**Re: Defect Information Report – Supplemental Report No. 11
10V-177 School Bus, 10V178 Non School Bus, FL-577
Hydraulic Brake Switches – Revised Dealer Bulletin**

THIRD REVISED NOTICE

Subject: Hydraulic Brake Switches

Models Affected: Specific Freightliner Custom Chassis B2 school bus chassis (Thomas Built Buses Saf-T-Liner C2), S2 shuttle bus chassis, MC motorhome chassis, and Freightliner Business Class M2 vehicles, manufactured January 19, 2005, through May 5, 2010.

Fig. 3, Brake Switch Installation (fixed pedal shown)

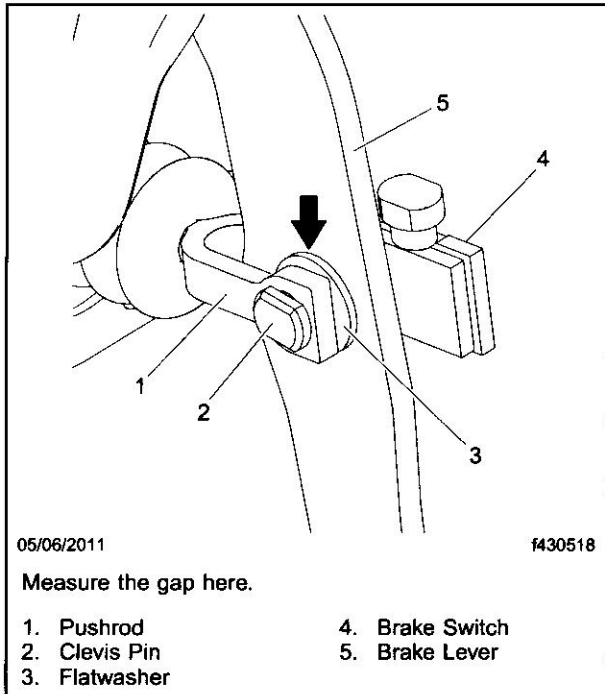
5. Using a feeler gauge, measure the space between the flatwasher and the brake pedal as shown in Fig. 3.
If the gap is *less than 1.2 mm*, replace the brake pedal. Go to "Hydraulic Brake Pedal Replacement" in these Work Instructions.
If the gap is *1.2 mm or more*, no further work is needed.
6. Attach the new harness pigtail to the existing harness and the newly installed brake switch. Use tie straps to secure excess wiring away from the throttle pedal.
7. Check for proper brake light operation.
8. Clean a spot on the base label (Form WAR259) and attach a completion sticker for FL577 (Form WAR260) to the base label.

Fig. 4, New Brake Switch Installation (fixed pedal)

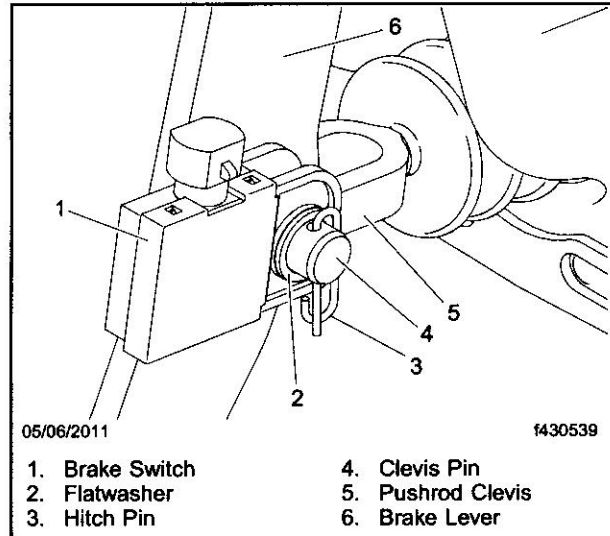
The hydraulic brake switches will be replaced to control stop lamp functionality. The hydraulic brake pedals will be inspected for side-to-side play and twist and will be replaced as necessary.

Fig. 6, Removing the Fixed Brake Pedal

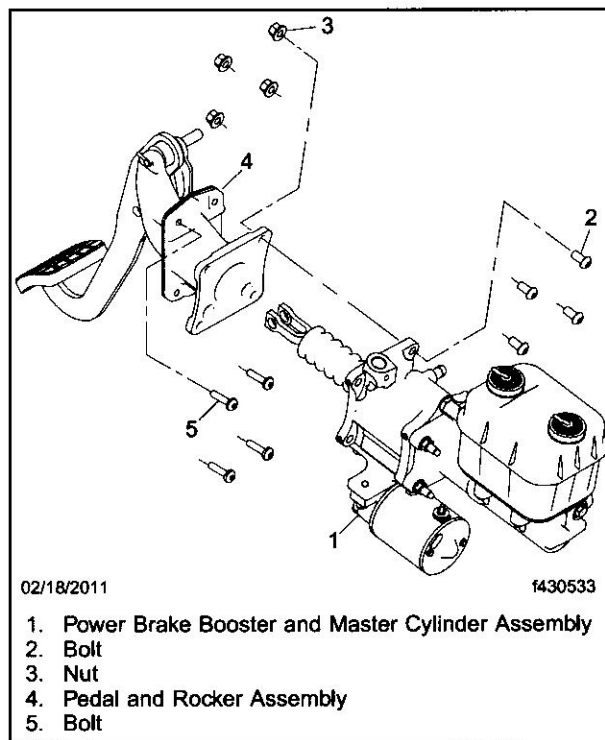
1. Remove the cotter pin from the brake clevis and remove the clevis pin from the brake pedal. See Fig. 6.
2. Disconnect the master cylinder from the brake cylinder and support the master cylinder by zip tying it to the engine. Be careful not to bend the hydraulic hard lines.
3. Remove the bolts holding the brake pedal to the frontwall, then pull the brake pedal through the frontwall.
4. Use the existing bolts and install the new brake pedal. Tighten the bolts 10 to 13 lbf-ft (14 to 18 N-m).
5. Connect the master cylinder to the brake pedal.
6. Go to "Hydraulic Brake Light Switch Replacement" in these Work Instructions.

Fig. 1, Brake Switch Location, Fixed Brake Pedal

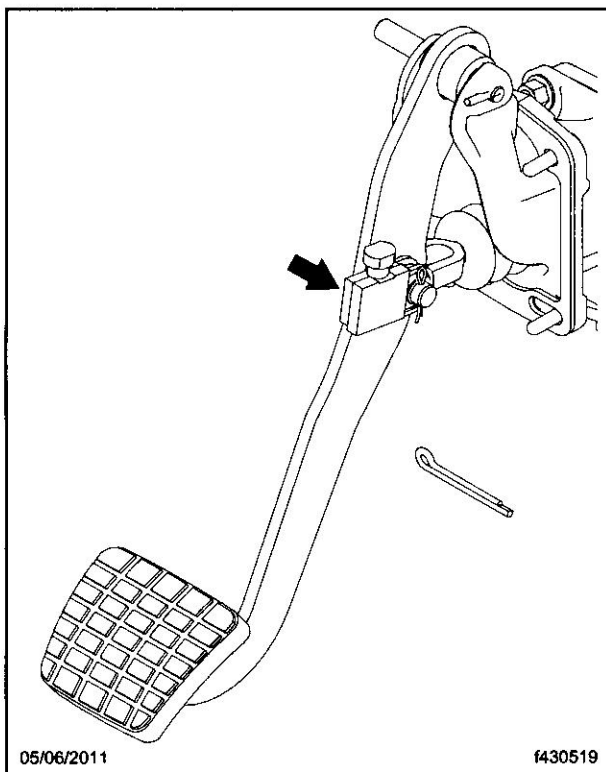
2. Park the vehicle on a level surface, shut down the engine, apply the parking brake, and chock the tires.
3. Determine whether the brake pedal is fixed or adjustable. See **Fig. 1** and **Fig. 2**.
If the brake pedal is adjustable, no inspection is needed. Go to "Hydraulic Brake Light Switch Replacement" in these Work Instructions.
If the brake pedal is fixed, go to the next step.

1. Locate the brake switch on the brake pedal. See **Fig. 1** for location on a fixed brake pedal. See **Fig. 2** for the location on an adjustable brake pedal.
2. Cut the tie strap on the harness leads going to the brake switch, and unplug the switch.
3. Remove the cotter pin, flatwashers, clevis pin, and brake switch and discard all of these parts.
4. Install the new clevis pin, flatwashers, brake switch, and hitch pin from the kit. Make certain one flatwasher is between the pushrod and the brake lever as shown in **Fig. 3**.
Make certain the other flatwasher is between the brake switch and the hitch pin, and that the hitch pin is installed as shown in **Fig. 4** for fixed brake pedal installations, or **Fig. 5** for adjustable brake pedal installations.
For vehicles with an adjustable brake pedal, go to Step 6.
For vehicles with a fixed brake pedal, go to the next step.

4. Inspect the brake pedal for side-to-side play by moving the pedal from left to right. Measure travel at the brake pedal cover.
If the side-to-side play is *more than 6 mm*, replace the brake pedal. Go to "Hydraulic Brake Pedal Replacement" in these Work Instructions.
If the side-to-side play is *6 mm or less*, do **not** replace the pedal. Go to "Hydraulic Brake Light Switch Replacement" in these Work Instructions.
